Permit of Authorization to Construct an On-Site Sewage Facility Permit Valid For One Year From Date Issued

Permit Number: 118373

OSSF DESIGN

Location: 7008 Circle Oak Dr. Bulverde TX 78163

Entirety of Property and Septic ARE located within 100YR Flood Plain. SITE PLAN & OSSF DESIGN:

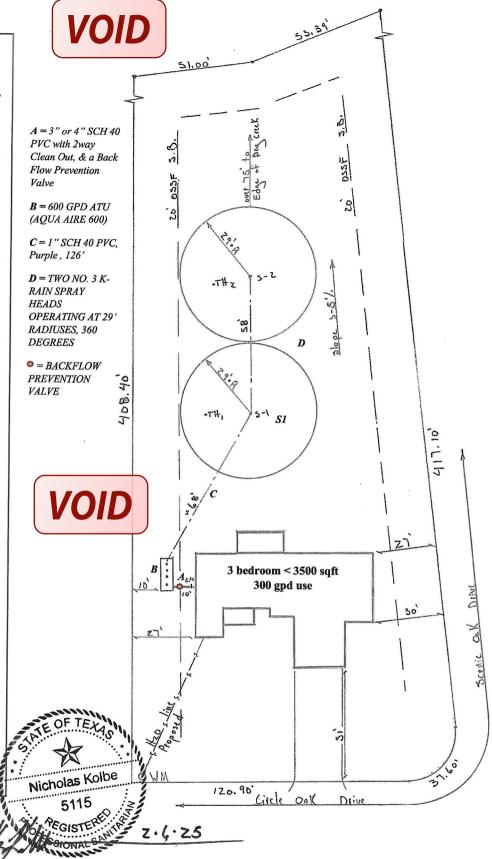
- Submit a copy of the approved building permit from the City of Bulverde, or a letter from the city indicating that a building permit is not required.
- 2. Owner signature needed on the maintenance contract.
- There appears to be a typo on the reserve capacity noted on the design page. 80 gallons indicated, design requires 100 gallons.
- It appears that this property is located within the flood plain. The site evaluation must include this information and the flood plain must be identified on the design. Planning materials must indicate that the system has been placed so that it will not be damaged in a flood event, resulting in contamination of the environment. Clarify if any additional provisions are required for the septic tank.
- 5. Revise as needed and resubmit.
